NO: 18-14-99

**SUBJECT: Drone Like Noise During Warm Engine Idling**

**DATE: June 18, 1999**

# FIGURE 1

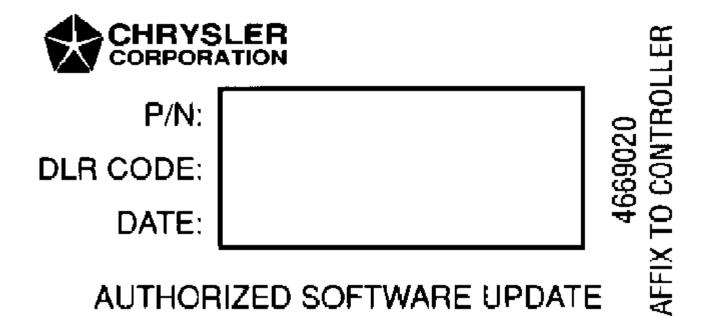
- 9. Type the necessary information on the "Authorized Software Update Label" p/n 04669020 (Figure 1). Attach the label to the JTEC PCM and cover the label with the clear plastic overlay
- 10. Type the necessary information on the "Authorized Modification Label" p/n 04275086 and attach the label near the VECI label (Figure 2).
